UNITED STATES ARMS CONTROL AND DISARMAMENT AGENCY,
WASHINGTON, DC, DAN FENSTERMACHER
PAGE 1 OF 13

COMMENTS ON DRAFT PEIS ON DISPOSITION

Attached are written comments and selected pages with comments in the margins. These are preliminary comments only, and not meant to imply ACDA concurrence with the entire Draft PEIS.

Figure 5-3. Surplus Plutonium Disposition Alternatives.

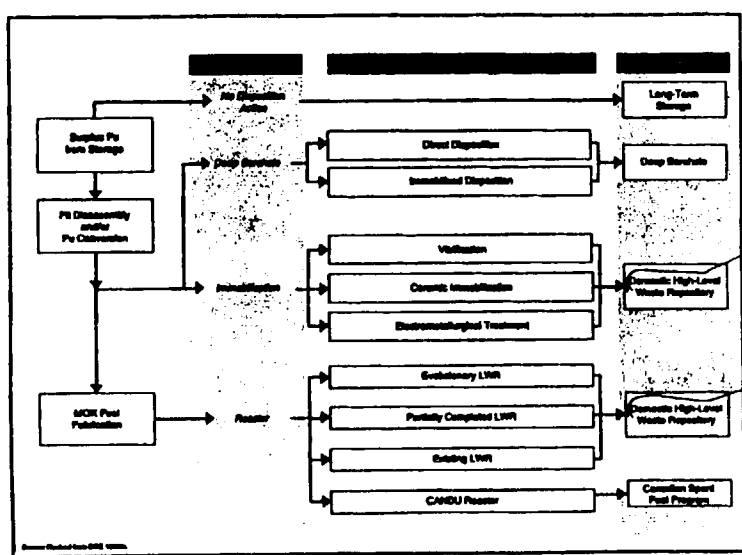
3. Finally, the "destinations" at the end of the disposition alternatives in the figure on p. S-11 are confusing.

Since the figure gives the destination "Domestic High Level Waste Repository" for Immobilization and Reactor options, but "Deep Borehole" for the deep borehole option, it implies that the PEIS is comparing the immobilization and reactor options all the way through to the final repository. I had understood this not to be the case, but rather that the options were being compared only through the achievement of the "spent fuel standard," which is achieved during "interim" storage of the vitrified forms or in spent fuel pools (or dry storage) for the reactor options. This figure should not imply that the more difficult problem of ultimate repositories is being addressed in the comparison as well. I've proposed a wording fix in the margins.

Comment noted. This figure has been modified to clarify that the NWP-HLW repository is not included in the scope of the environmental analysis.

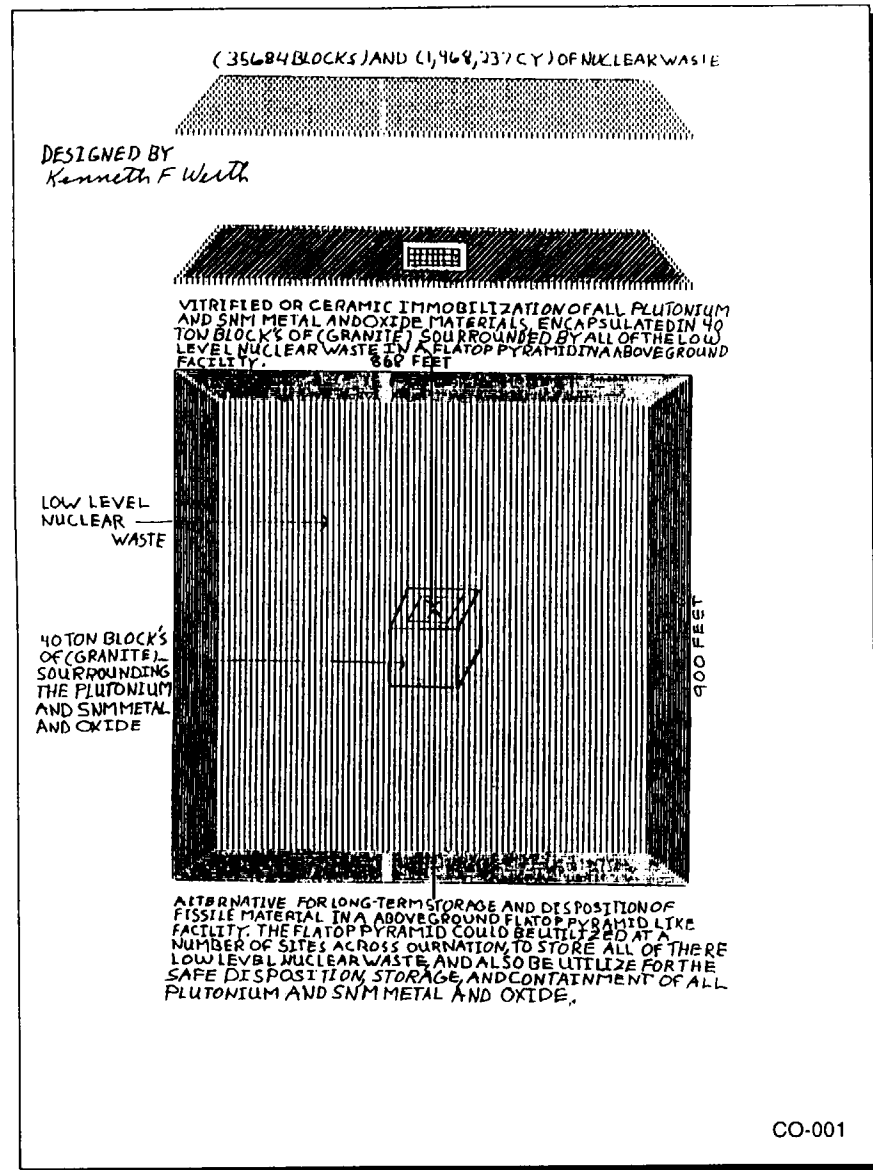
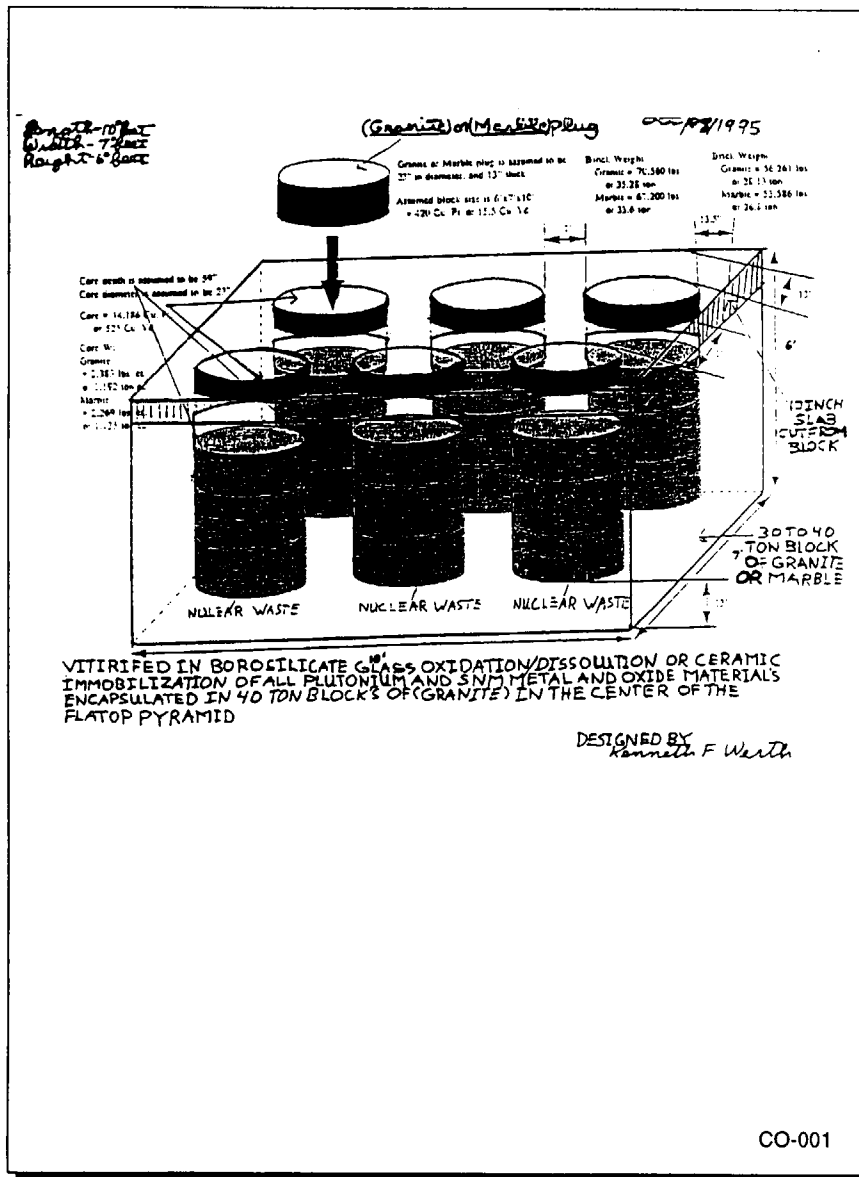
(4) An above ground Flatop Pyramid Type facility will provide Storage and Disposition of all Low Level, Plutonium and SNM Metals and Oxide Materials, and will be seen as the first "State-of-the-Art" on-site Storage and Disposition facility in the world.

versus the more than 120 acres, estimated to be needed for an underground waste dump. If estimates of waste quantity are not accurate at each site, the Flatop Pyramid type facility, can be built on less land use, and capped at a lower level, or additional levels can be added. Flatop Pyramids can be sized for each site based on the estimated quantities of waste to be stored.

The Department of Energy appreciates the commentator's submission of the conceptual design of the flat-top pyramid storage facility. However, one of the screening criteria for storage, technical viability, calls for a high degree of confidence that the facility must provide safe and secure storage of nuclear materials for at least 50 years. The structural integrity of this design is not proven, and the size and shape of the facility could attract unwanted attention. Since there is an urgent need for implementation of the Proposed Action, and existing facilities and design can accomplish the storage mission, it would not be prudent to use additional time and cost to develop and demonstrate new designs.
